**COUNTY OF SAN MATEO
PLANNING AND BUILDING DEPARTMENT**

SUBJECT: EXECUTIVE SUMMARY: Consideration of a Non-Conforming Use Permit, Coastal Development Permit, and Design Review Permit, pursuant to Sections 6133.3b, 6328.4 and 6565.3 of the San Mateo County Zoning Regulations, respectively, to allow construction of a new 1,732 sq. ft., two-story single-family residence, plus a 380 sq. ft. two-car attached garage, located on an existing 4,400 sq. ft. legal non-conforming parcel where the S-94 Combining District requires a minimum parcel size of 10,000 square feet. The project includes extension of Cortez Avenue by approximately 60 feet for project access and a new firetruck turnaround. The Non-Conforming Use Permit is required to allow development on a non-conforming parcel that proposes right and left side setbacks of 7 feet each, where 10 feet is the minimum allowed for each side. No trees are proposed for removal. The project is not appealable to the California Coastal Commission.

County File Number: PLN 2018-00397 (Irfan)

LANDSCAPING Plan

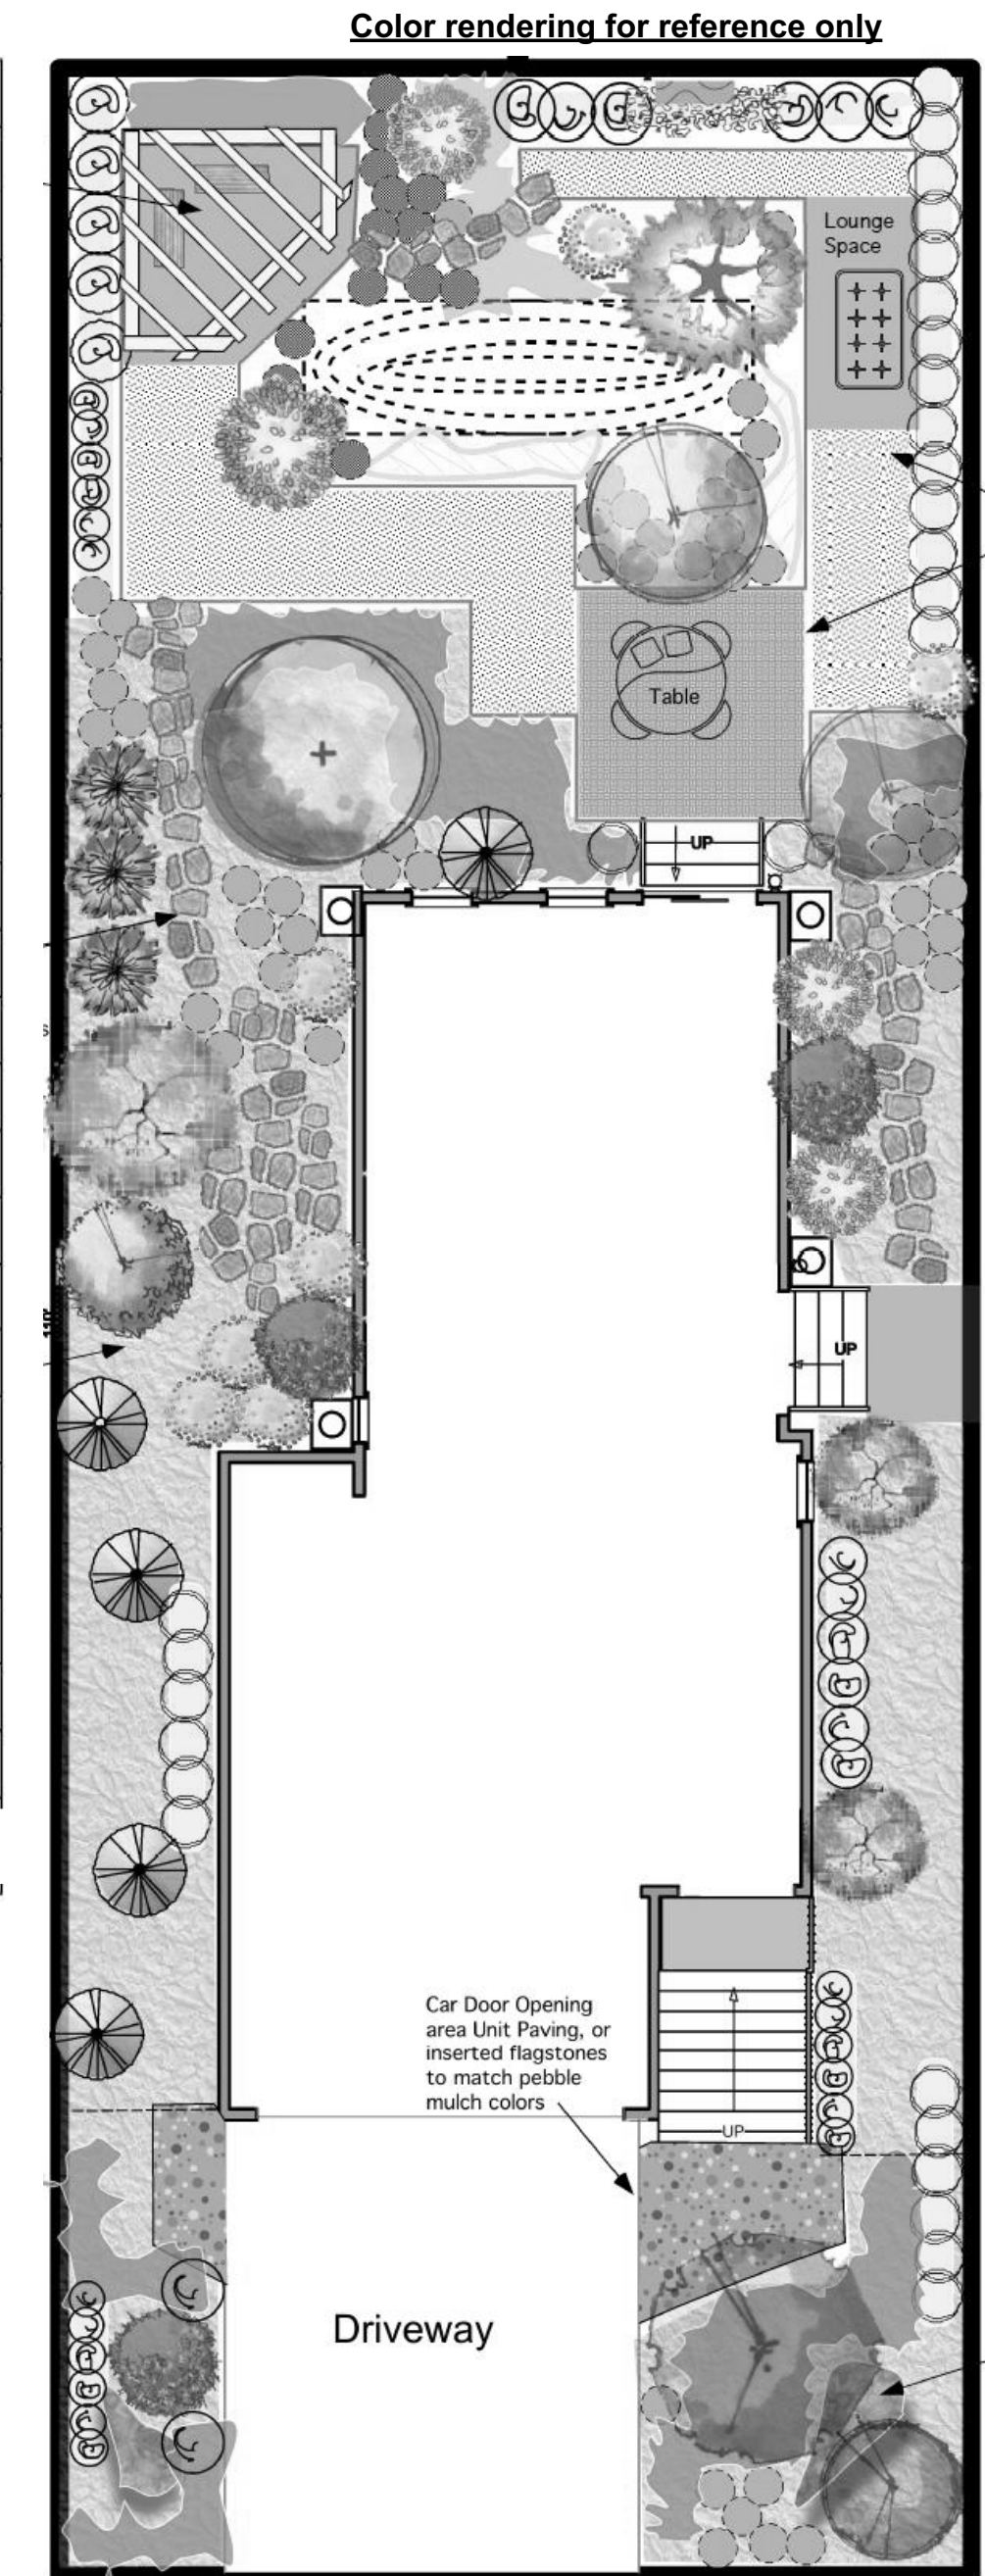
14. Group plantings for a more natural effect.
Redesign: Landscape is now redone by a Landscape architect. We went over and make it really nice landscaping design. Groups of plants now introduce in the plan.

15. Incorporate a tree/plant species, plants that grow to a more substantial height and have longevity in a coastal zone, in the landscape plan. Roses are not recommended.
Redesign: Landscape design is now done by Landscape Architect. Adding tens of new plants to the plan by Landscape architect. Roses removed.

17. Reduce grass area significantly.
Redesign: Grass removed from the plans. Landscape design is now redone by a Landscape architect.
- Recommendations (optional):**

FLOOR PLANS

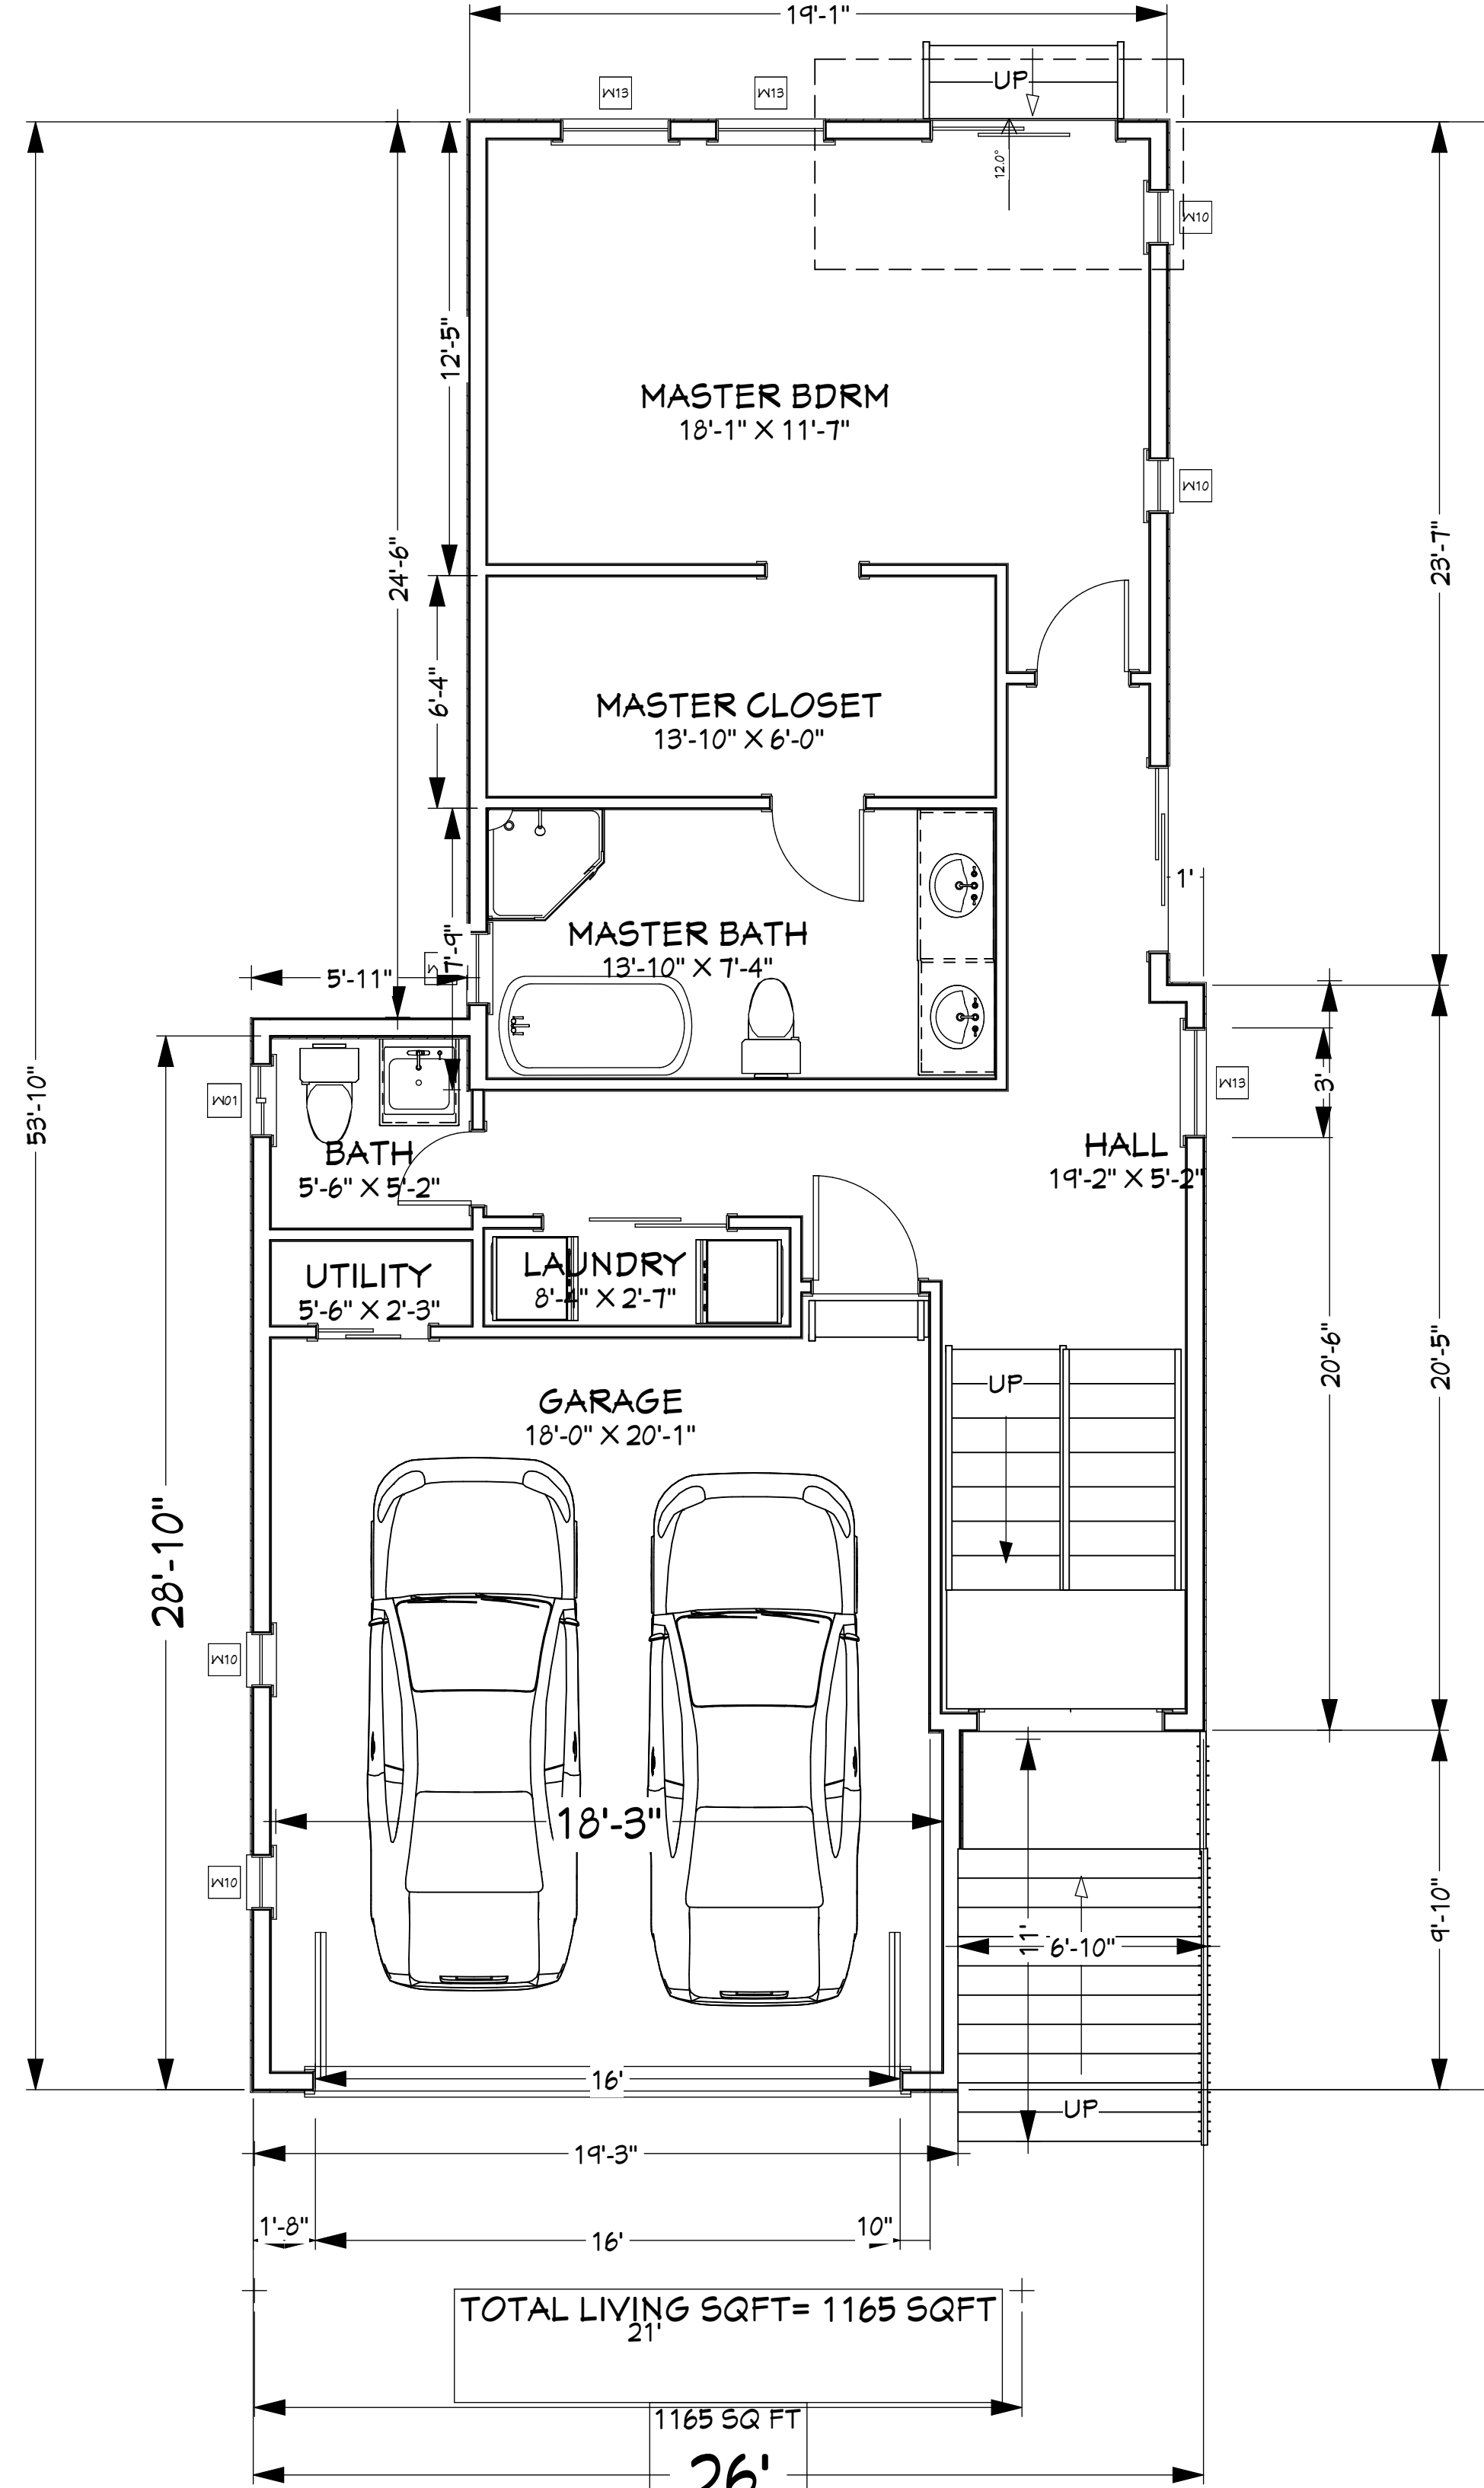
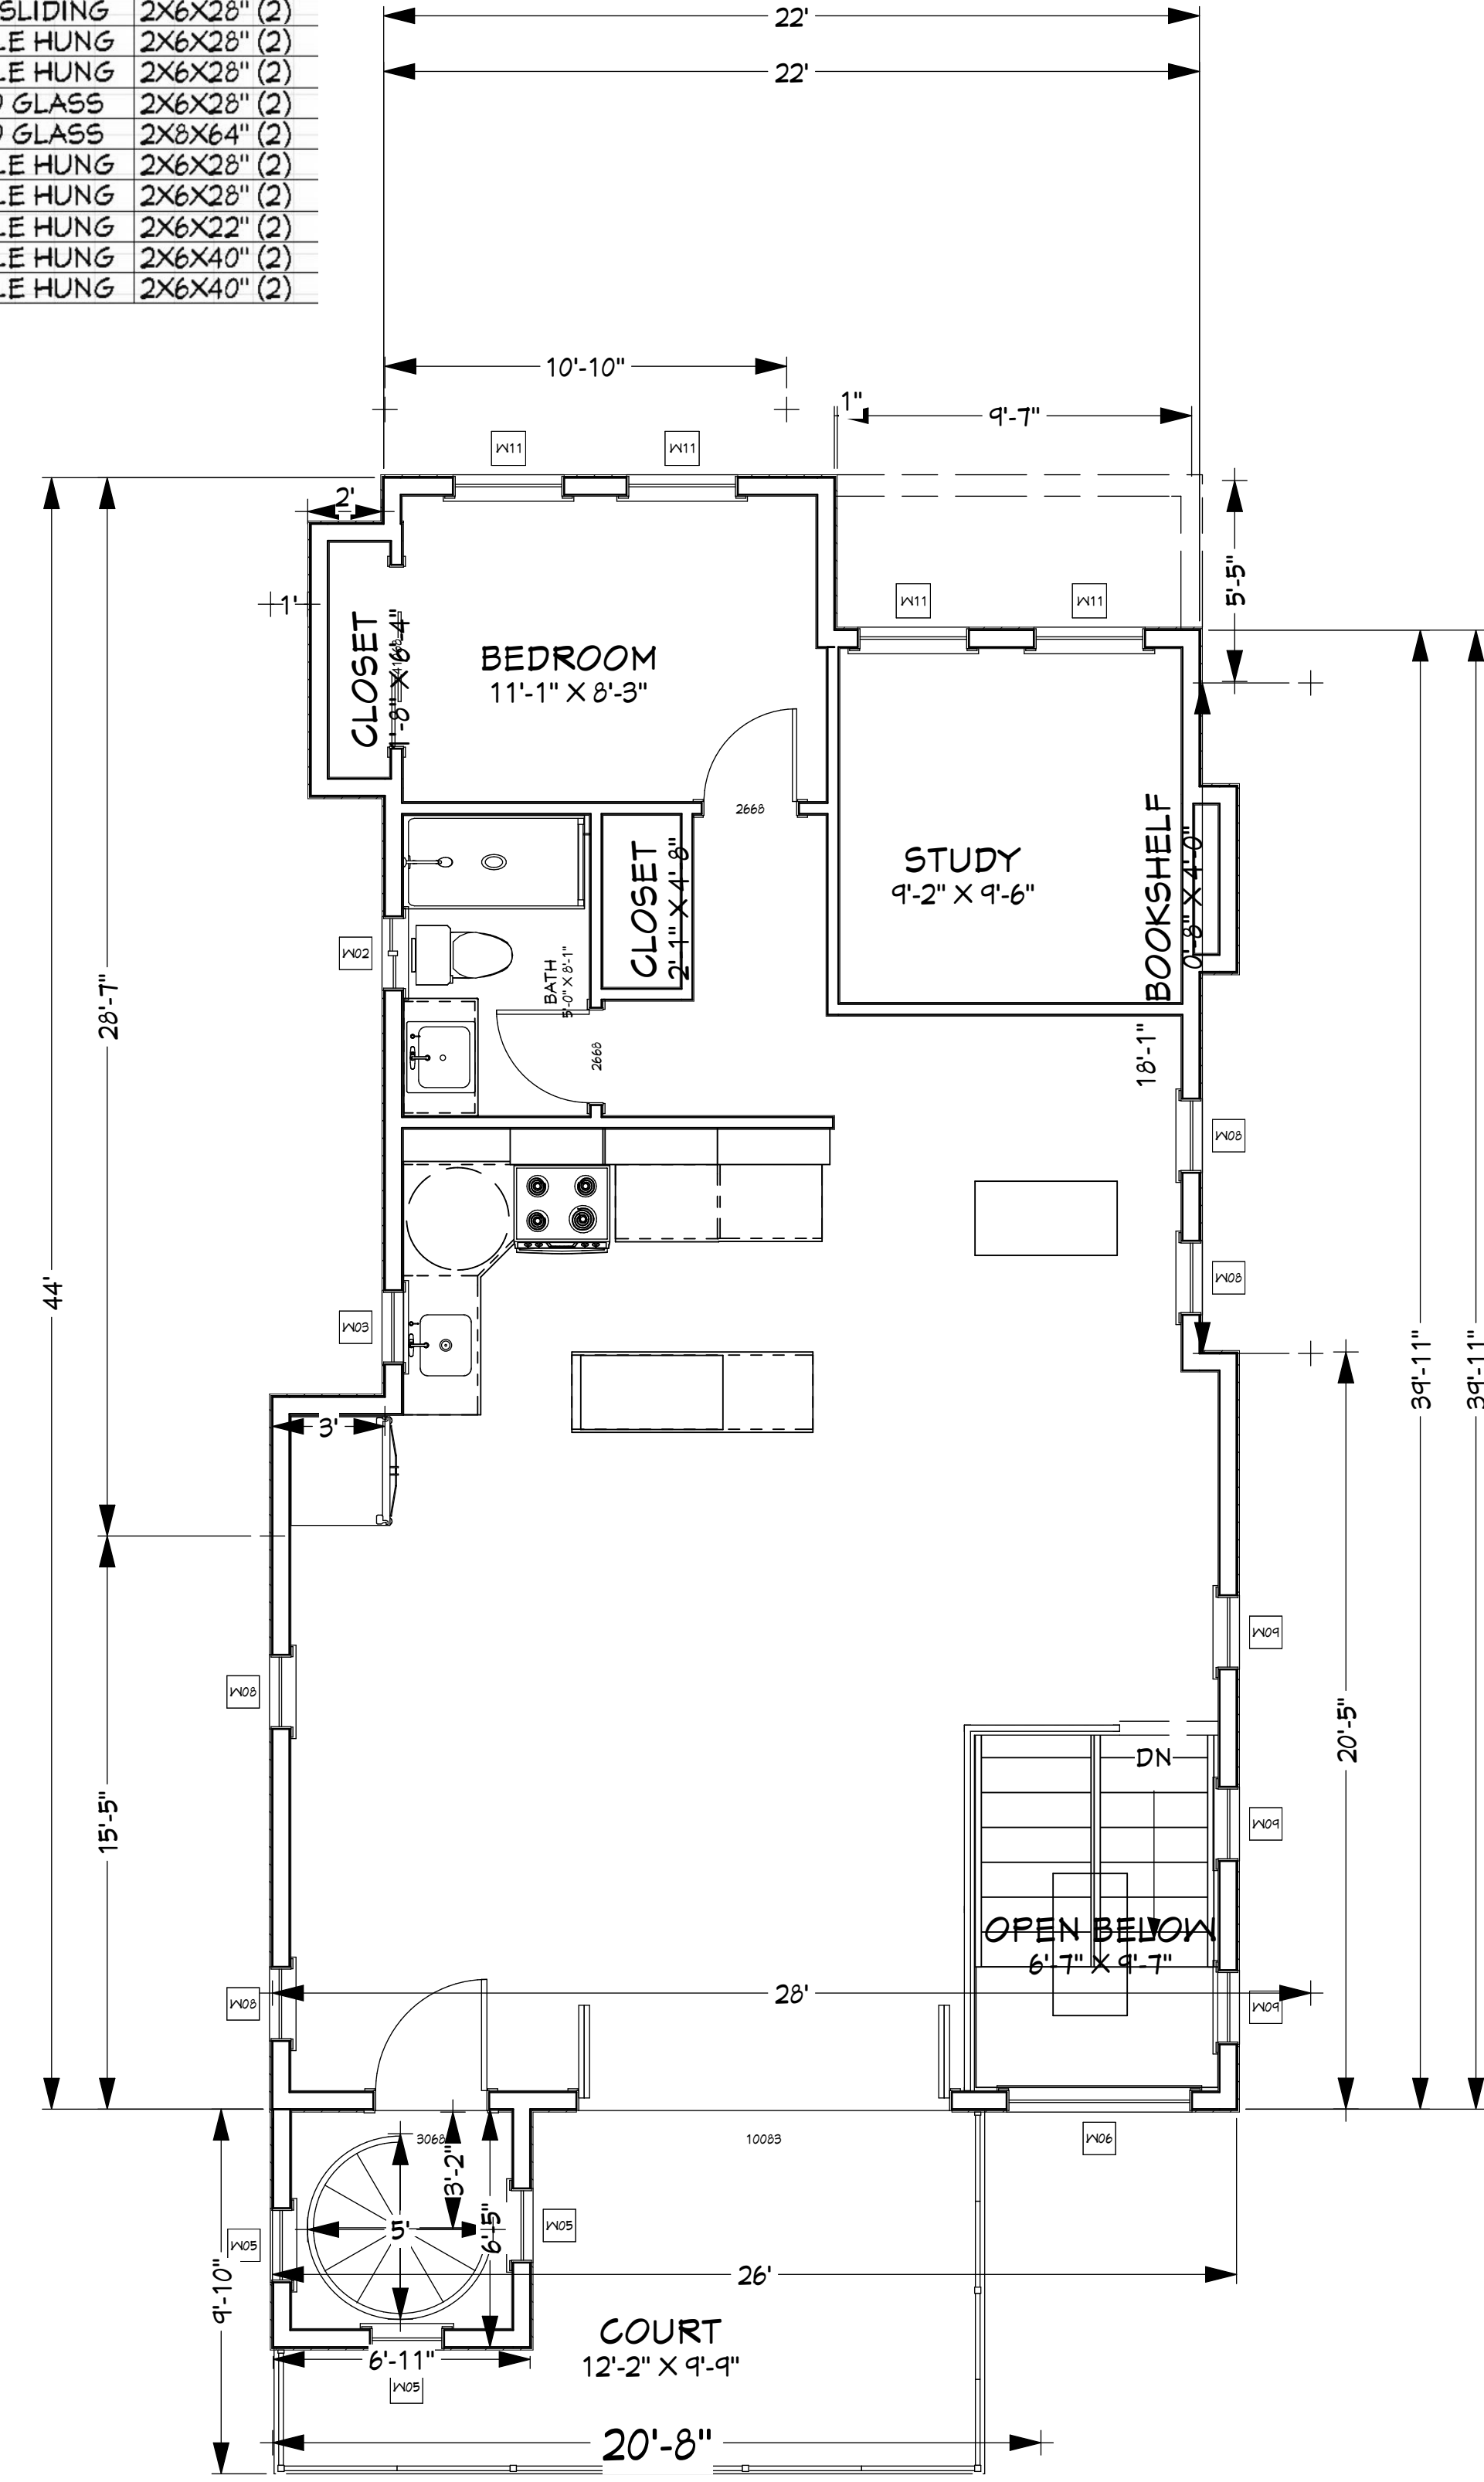
12. Garage parking does not provide minimum clear dimensions (18' wide by 19' long). Correct this to ensure it does not affect the exterior design in the permit drawings.
Redesign: Garage now meeting the minimum clear dimension. Actually little bigger than what is required. 38x0.

12. Garage parking does not provide minimum clear dimensions (18' wide by 19' long). Correct this to ensure it does not affect the exterior design in the permit drawings.
